Kenwood Ave/ Delaware Ave
- Inadequate Buffer between Pedestrian/Traffic (2)
- Limited Sight Distance at Intersection (1)
- Inappropriate Parking in the striped area (2)
-- Provide curb for pedestrian safety (1)

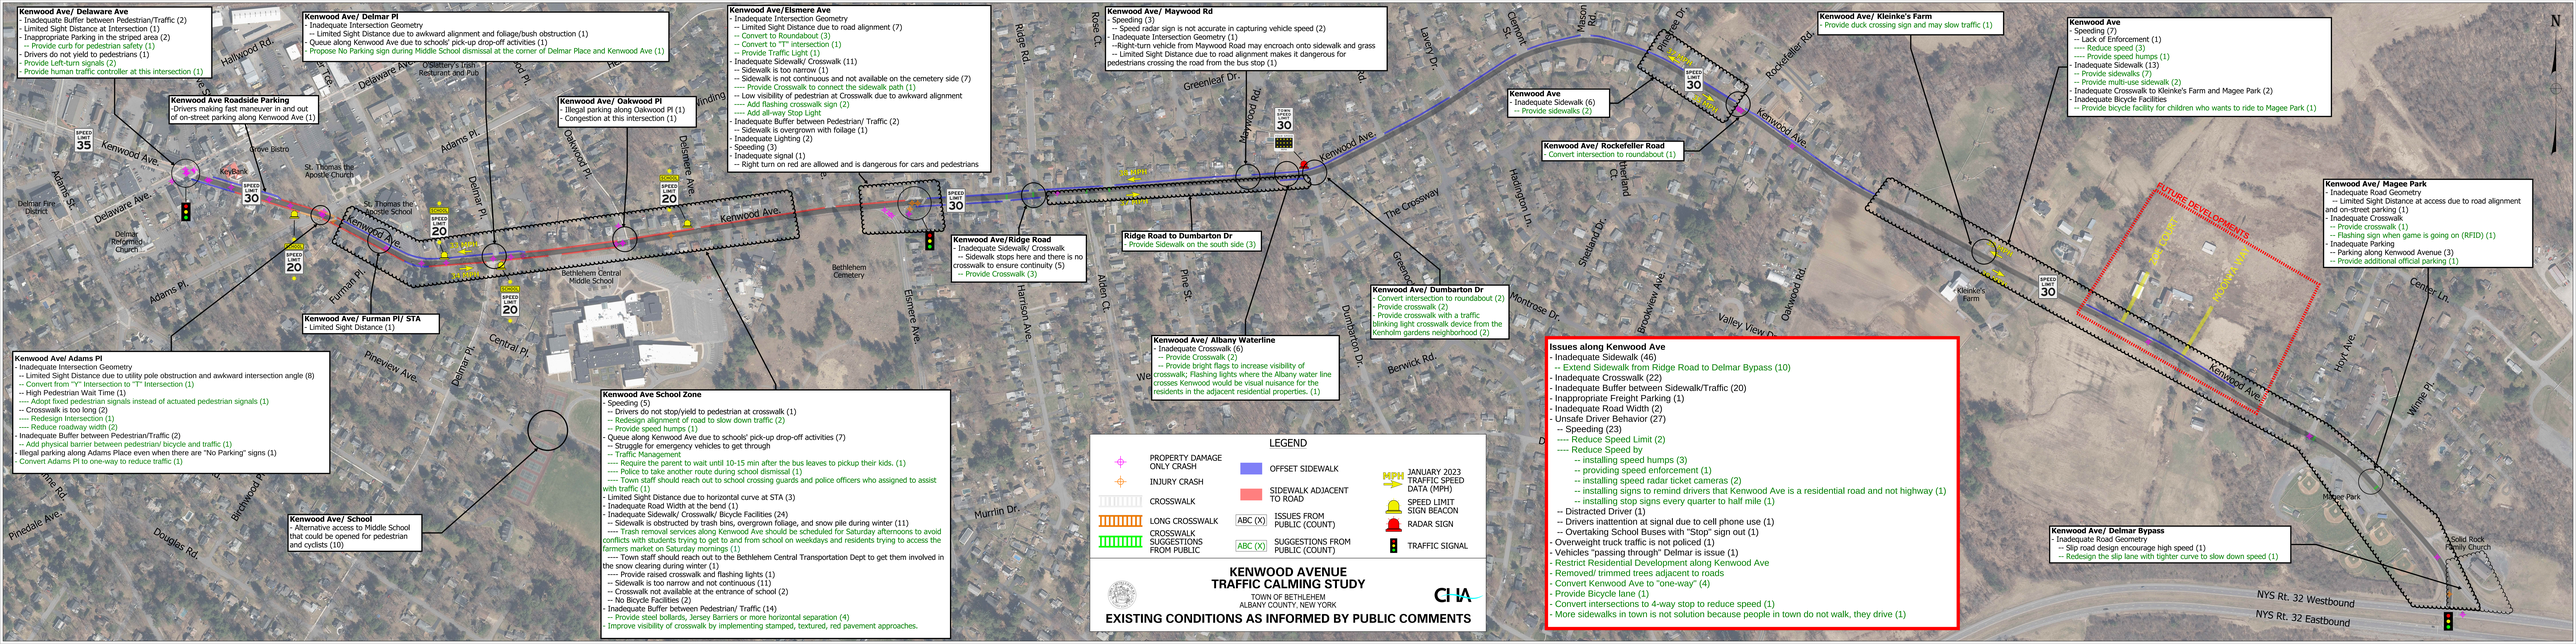
- Drivers do not yield to pedestrians (1)
- Provide Left-turn signals (2)
- Provide human traffic controller at this intersection (1)
Kenwood Ave/ Delmar Pl

- Inadequate Intersection Geometry
-- Limited Sight Distance due to awkward alignment and foliage/bush obstruction (1)
- Queue along Kenwood Ave due to schools' pick-up drop-off activities (1)

- Propose No Parking sign during Middle School dismissal at the corner of Delmar Place and Kenwood Ave (1)
Kenwood Ave/Elsmere Ave
- Inadequate Intersection Geometry
-- Limited Sight Distance due to road alignment (7)
-- Convert to Roundabout (3)
-- Convert to "T" intersection (1)
-- Provide Traffic Light (1)

- Inadequate Sidewalk/ Crosswalk (11)
-- Sidewalk is too narrow (1)
-- Sidewalk is not continuous and not available on the cemetery side (7)
---- Provide Crosswalk to connect the sidewalk path (1)
-- Low visibility of pedestrian at Crosswalk due to awkward alignment
---- Add flashing crosswalk sign (2)
---- Add all-way Stop Light

- Inadequate Buffer between Pedestrian/ Traffic (2)
-- Sidewalk is overgrown with foliage (1)
- Inadequate Lighting (2)
- Speeding (3)
- Inadequate signal (1)
-- Right turn on red are allowed and is dangerous for cars and pedestrians
Kenwood Ave/ Maywood Rd

- Speeding (3)
-- Speed radar sign is not accurate in capturing vehicle speed (2)
- Inadequate Intersection Geometry (1)
--Right-turn vehicle from Maywood Road may encroach onto sidewalk and grass
-- Limited Sight Distance due to road alignment makes it dangerous for pedestrians crossing the road from the bus stop (1)
Kenwood Ave/ Kleinke's Farm

- Provide duck crossing sign and may slow traffic (1)
Kenwood Ave
- Speeding (7)
-- Lack of Enforcement (1)
---- Reduce speed (3)
---- Provide speed humps (1)

- Inadequate Sidewalk (13)
-- Provide sidewalks (7)
-- Provide multi-use sidewalk (2)
- Inadequate Crosswalk to Kleinke's Farm and Magee Park (2)
- Inadequate Bicycle Facilities
-- Provide bicycle facility for children who wants to ride to Magee Park (1)
Kenwood Ave/ Magee Park

- Inadequate Road Geometry
-- Limited Sight Distance at access due to road alignment and on-street parking (1)
- Inadequate Crosswalk
-- Provide crosswalk (1)
-- Flashing sign when game is going on (RFID) (1)

- Inadequate Parking
-- Parking along Kenwood Avenue (3)
-- Provide additional official parking (1)
Kenwood Ave Roadside Parking
-Drivers making fast maneuver in and out of on-street parking along Kenwood Ave (1)
Kenwood Ave/ Oakwood Pl

- Illegal parking along Oakwood Pl (1)
- Congestion at this intersection (1)
Kenwood Ave
- Inadequate Sidewalk (6)
-- Provide sidewalks (2)
Kenwood Ave/ Rockefeller Road

- Convert intersection to roundabout (1)
Kenwood Ave/Ridge Road
- Inadequate Sidewalk/ Crosswalk
-- Sidewalk stops here and there is no crosswalk to ensure continuity (5)
-- Provide Crosswalk (3)
Ridge Road to Dumbarton Dr

- Provide Sidewalk on the south side (3)
Kenwood Ave/ Dumbarton Dr
- Convert intersection to roundabout (2)
- Provide crosswalk (2)
- Provide crosswalk with a traffic blinking light crosswalk device from the Kenholm gardens neighborhood (2)
Kenwood Ave/ Albany Waterline

- Inadequate Crosswalk (6)
-- Provide Crosswalk (2)
-- Provide bright flags to increase visibility of crosswalk; Flashing lights where the Albany water line crosses Kenwood would be visual nuisance for the residents in the adjacent residential properties. (1)
Kenwood Ave/ Furman Pl/ STA

- Limited Sight Distance (1)
Kenwood Ave/ Adams Pl
- Inadequate Intersection Geometry
-- Limited Sight Distance due to utility pole obstruction and awkward intersection angle (8)
-- Convert from "Y" Intersection to "T" Intersection (1)
-- High Pedestrian Wait Time (1)
---- Adopt fixed pedestrian signals instead of actuated pedestrian signals (1)
-- Crosswalk is too long (2)
---- Redesign Intersection (1)
---- Reduce roadway width (2)

- Inadequate Buffer between Pedestrian/Traffic (2)
-- Add physical barrier between pedestrian/ bicycle and traffic (1)
- Illegal parking along Adams Place even when there are "No Parking" signs (1)

- Convert Adams Pl to one-way to reduce traffic (1)
Kenwood Ave School Zone
- Speeding (5)
-- Drivers do not stop/yield to pedestrian at crosswalk (1)
-- Redesign alignment of road to slow down traffic (2)
-- Provide speed humps (1)

- Queue along Kenwood Ave due to schools' pick-up drop-off activities (7)
-- Struggle for emergency vehicles to get through
-- Traffic Management
---- Require the parent to wait until 10-15 min after the bus leaves to pickup their kids. (1)
---- Police to take another route during school dismissal (1)
---- Town staff should reach out to school crossing guards and police officers who assigned to assist with traffic (1)

- Limited Sight Distance due to horizontal curve at STA (3)
- Inadequate Road Width at the bend (1)
- Inadequate Sidewalk/ Crosswalk/ Bicycle Facilities (24)
-- Sidewalk is obstructed by trash bins, overgrown foliage, and snow pile during winter (11)
---- Trash removal services along Kenwood Ave should be scheduled for Saturday afternoons to avoid conflicts with students trying to get to and from school on weekdays and residents trying to access the farmers market on Saturday mornings (1)
---- Town staff should reach out to the Bethlehem Central Transportation Dept to get them involved in the snow clearing during winter (1)
---- Provide raised crosswalk and flashing lights (1)
-- Sidewalk is too narrow and not continuous (11)
-- Crosswalk not available at the entrance of school (2)
-- No Bicycle Facilities (2)

- Inadequate Buffer between Pedestrian/ Traffic (14)
-- Provide steel bollards, Jersey Barriers or more horizontal separation (4)
- Improve visibility of crosswalk by implementing stamped, textured, red pavement approaches.
Kenwood Ave/ School

- Alternative access to Middle School that could be opened for pedestrian and cyclists (10)
Issues along Kenwood Ave
- Inadequate Sidewalk (46)
-- Extend Sidewalk from Ridge Road to Delmar Bypass (10)

- Inadequate Crosswalk (22)
- Inadequate Buffer between Sidewalk/Traffic (20)
- Inappropriate Freight Parking (1)
- Inadequate Road Width (2)
- Unsafe Driver Behavior (27)
-- Speeding (23)
---- Reduce Speed Limit (2)
---- Reduce Speed by
-- installing speed humps (3)
-- providing speed enforcement (1)
-- installing speed radar ticket cameras (2)
-- installing signs to remind drivers that Kenwood Ave is a residential road and not highway (1)
-- installing stop signs every quarter to half mile (1)
-- Distracted Driver (1)
-- Drivers inattention at signal due to cell phone use (1)
-- Overtaking School Buses with "Stop" sign out (1)

- Overweight truck traffic is not policed (1)
- Vehicles "passing through" Delmar is issue (1)
- Restrict Residential Development along Kenwood Ave
- Removed/ trimmed trees adjacent to roads

- Convert Kenwood Ave to "one-way" (4)
- Provide Bicycle lane (1)
- Convert intersections to 4-way stop to reduce speed (1)
- More sidewalks in town is not solution because people in town do not walk, they drive (1)
Kenwood Ave/ Delmar Bypass

- Inadequate Road Geometry
-- Slip road design encourage high speed (1)
-- Redesign the slip lane with tighter curve to slow down speed (1)
LEGEND
PROPERTY DAMAGE ONLY CRASH
INJURY CRASH
CROSSWALK
LONG CROSSWALK
CROSSWALK SUGGESTIONS FROM PUBLIC
OFFSET SIDEWALK
SIDEWALK ADJACENT TO ROAD
ABC (X) ISSUES FROM PUBLIC (COUNT)
ABC (X) SUGGESTIONS FROM PUBLIC (COUNT)
MPH JANUARY 2023 TRAFFIC SPEED DATA (MPH)
SPEED LIMIT SIGN BEACON
RADAR SIGN
TRAFFIC SIGNAL
KENWOOD AVENUE
TRAFFIC CALMING STUDY
TOWN OF BETHLEHEM
ALBANY COUNTY, NEW YORK
CHA
EXISTING CONDITIONS AS INFORMED BY PUBLIC COMMENTS
FUTURE DEVELOPMENTS
NYS Rt. 32 Westbound
NYS Rt. 32 Eastbound
Kenwood Ave
Delaware Ave
Delmar Pl
Adams Pl
Oakwood Pl
Maywood Rd
Ridge Rd
Elsmere Ave
Harrison Ave
Rockefeller Rd
Oakwood Rd
Hort Ave
Winne Pl
Center Ln
Hallowood Rd
Furman Pl
Central Pl
Pineview Ave
Pinedale Ave
Douglas Rd
Birchwood Rd
Murrin Dr
Greenleaf Dr
The Crossway
Berwick Rd
Valley View Dr
Brookview Ave
